Subject: Collin County Healthcare Facility, Parking Garage, and Medical Examiners
PCO No. 134; RFI #438 ME Door Hardware Conflicts

Issue No. 134 - RFI #438 ME Door Hardware Conflicts Amount

RFI #438: ME - Card Readers/Door Hardware/Security Clarifications.

ME-ES2.10

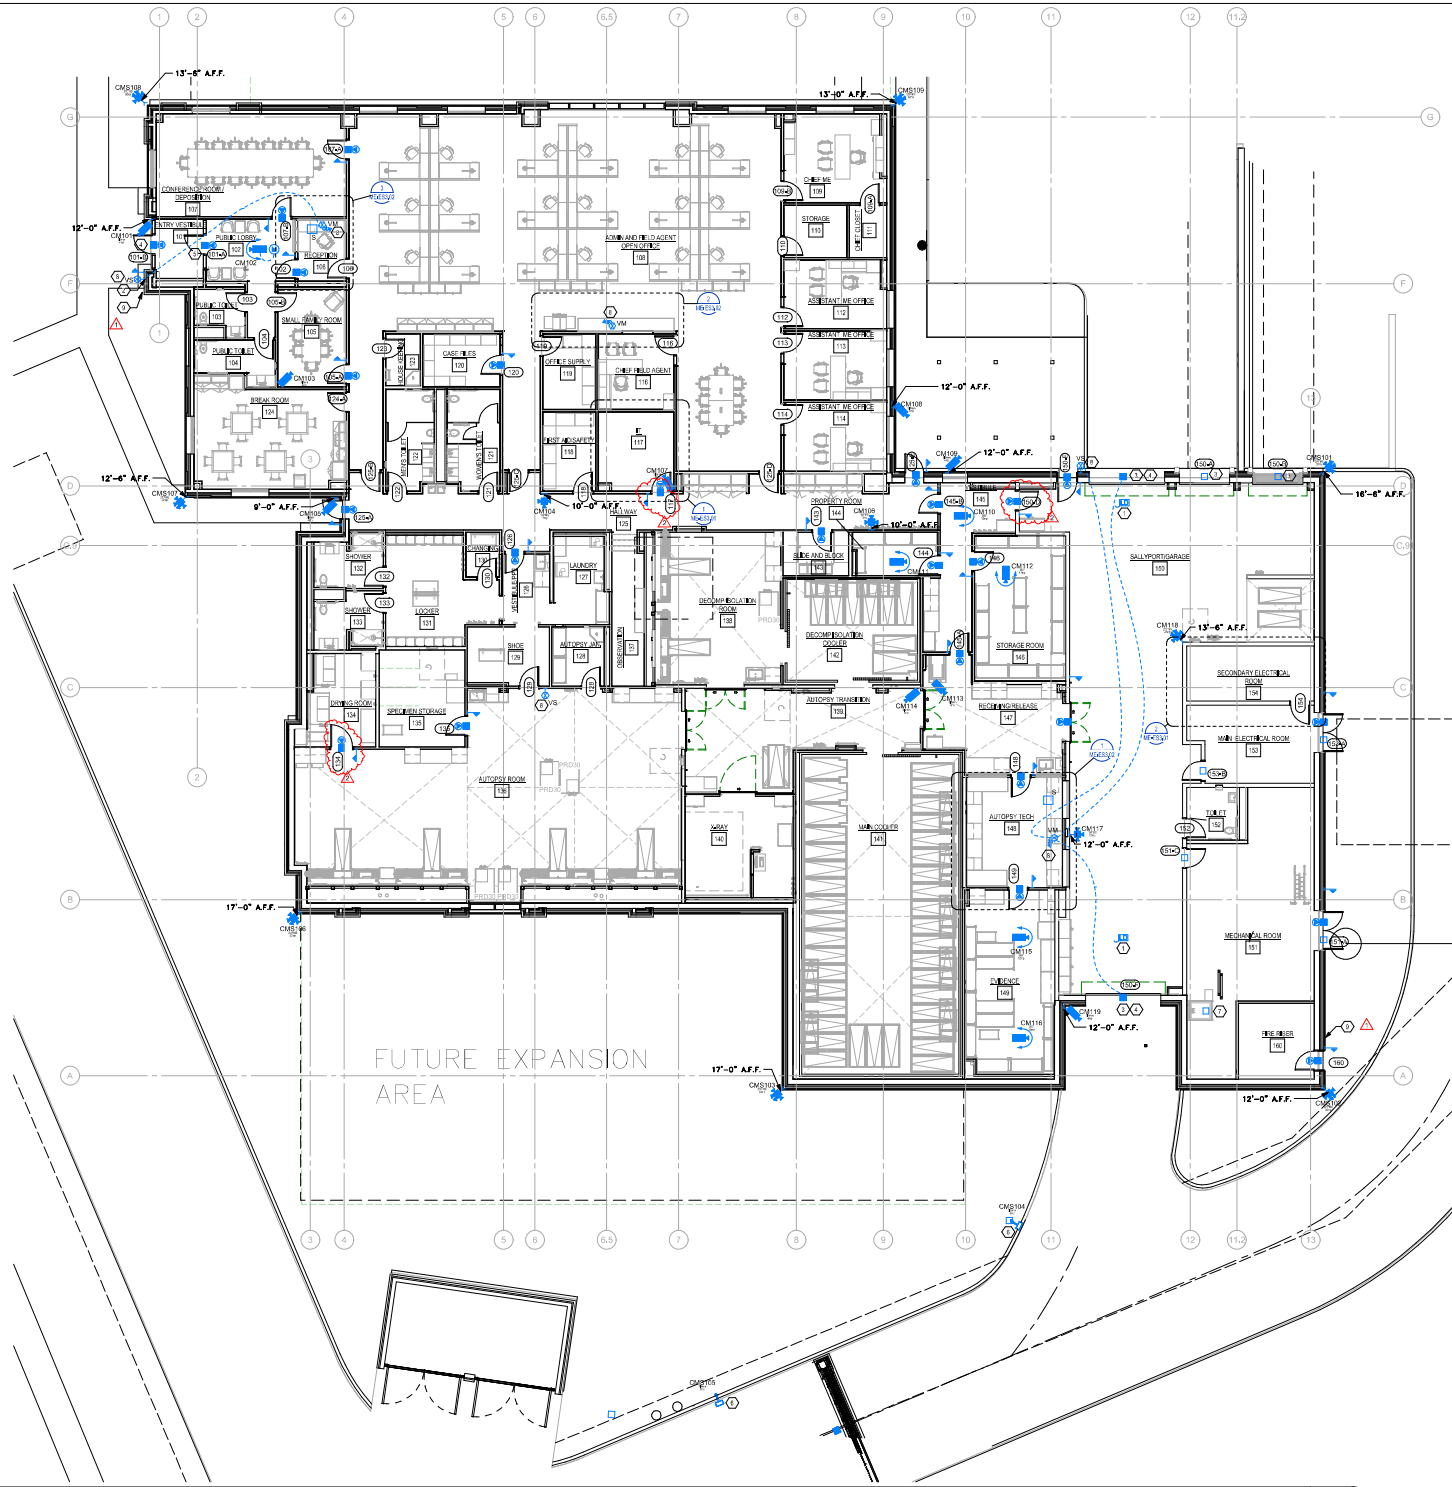
1. Doors 105B, 117, 119, 110, and 150D are identified. The door schedule indicates the presence of a card reader at these locations. The submittal has been approved with the inclusion of a card reader at the door. However, the security drawings do not depict a card reader on the specified door or wall, and their submittal was approved absent of one. Kindly confirm whether the addition of a card reader to the security drawings is required.

2. The door frames numbered 134 and 146 do not include card readers. Although the security drawing indicates a card reader (at the wall), the hardware lacks the appropriate hinges to connect it. Please clarify the hardware needed to properly install the card reader or the exit bar.

3. Door hardware for 145B, RFI 433, was already submitted. Conflict with submittal approval and door hardware.

4. Please review the hardware for door 160. It doesn't require any access control, but the security drawings show a card reader.

This RFI response didn't include all the details we asked for. Could you please update the security drawings to show the extra Card Readers? For door 117, the approved security submittals for rooms 134 and 150D didn't mention the card readers. Although the drawings were updated in RFI 315, the changes related to these card readers weren't clouded. When you revise the drawings, kindly make sure to clearly mark all the updates from RFI 315 with clouds for easy identification.

Refer to the attachment for response.
